THE MEMPHIS DEPOT TENNESSEE

AR File Number 117

July 18, 1995

SUBJECT: Response to EPA's, TDEC's, and Corps Huntsville's Comments on
DDMT's Draft Final OU-1, 2, 3 & 4 and Screening Sites Field
Sampling Plans and Generic Health and Safety Plan

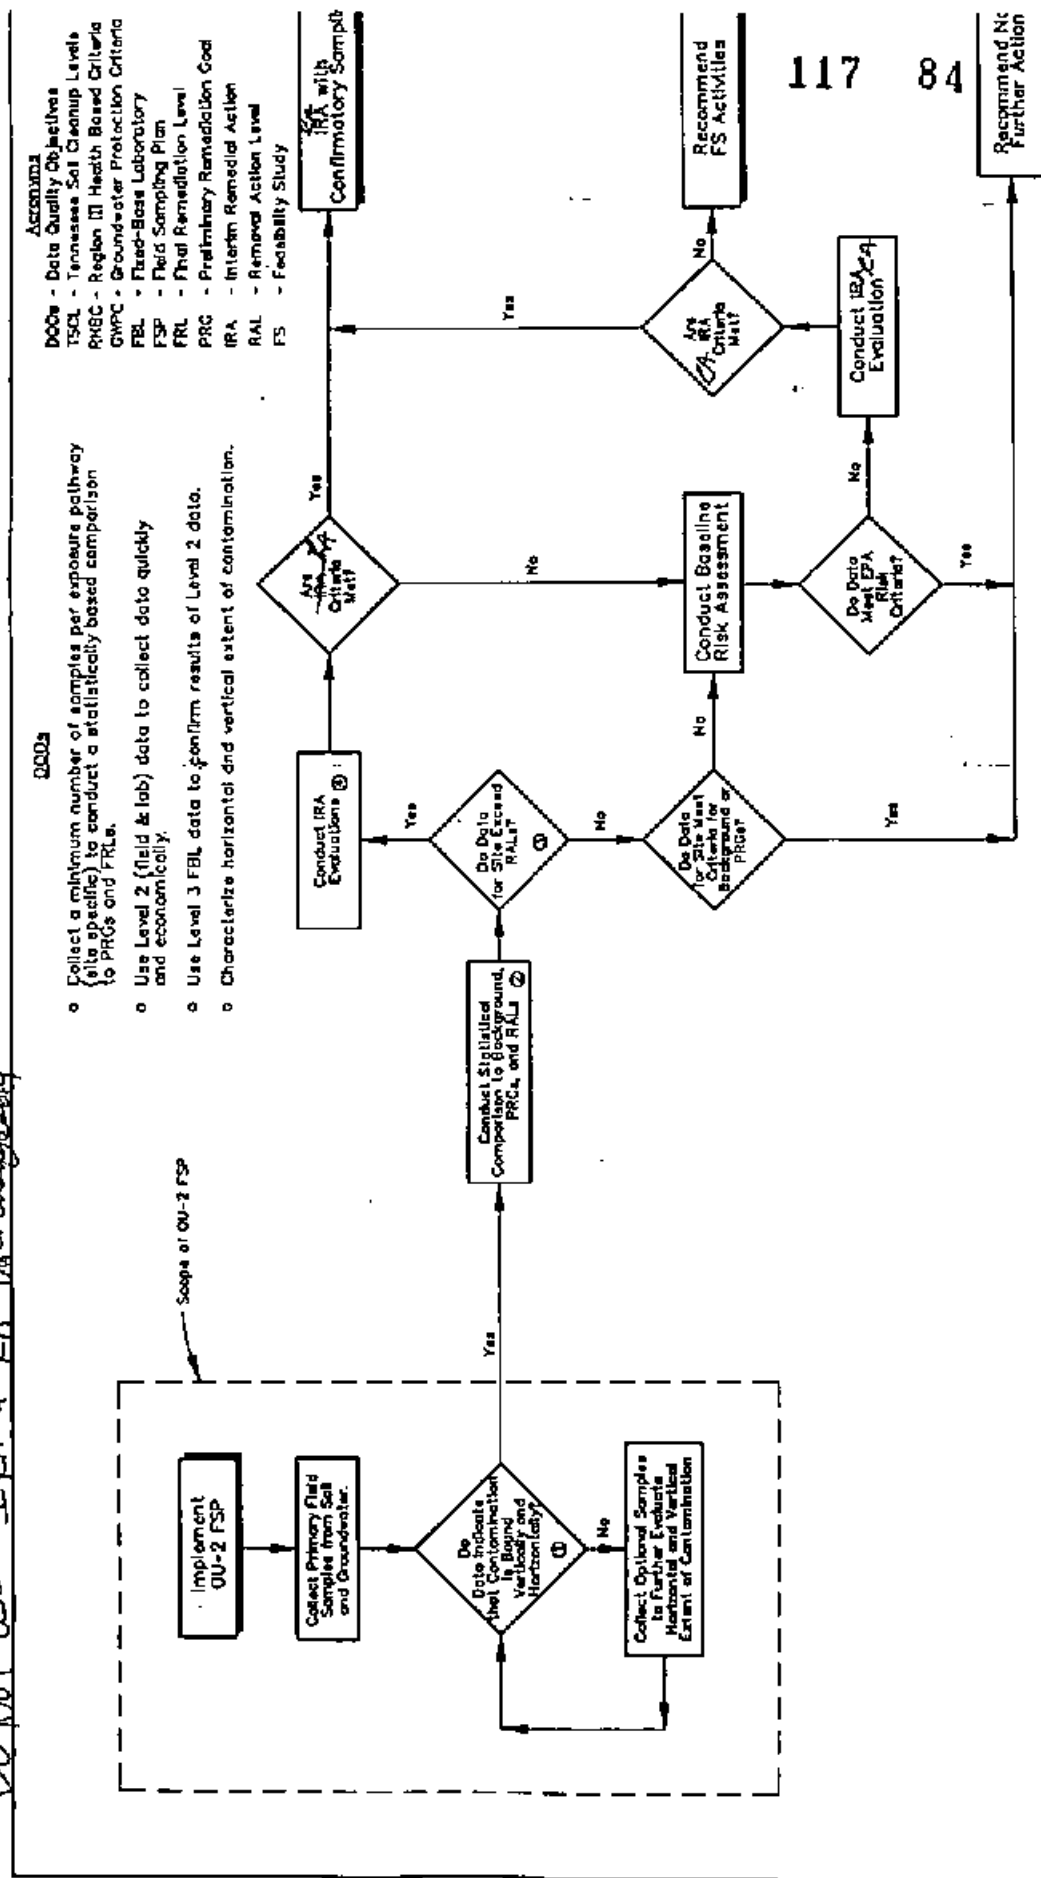
This Appears as a Remedial Action or Removal
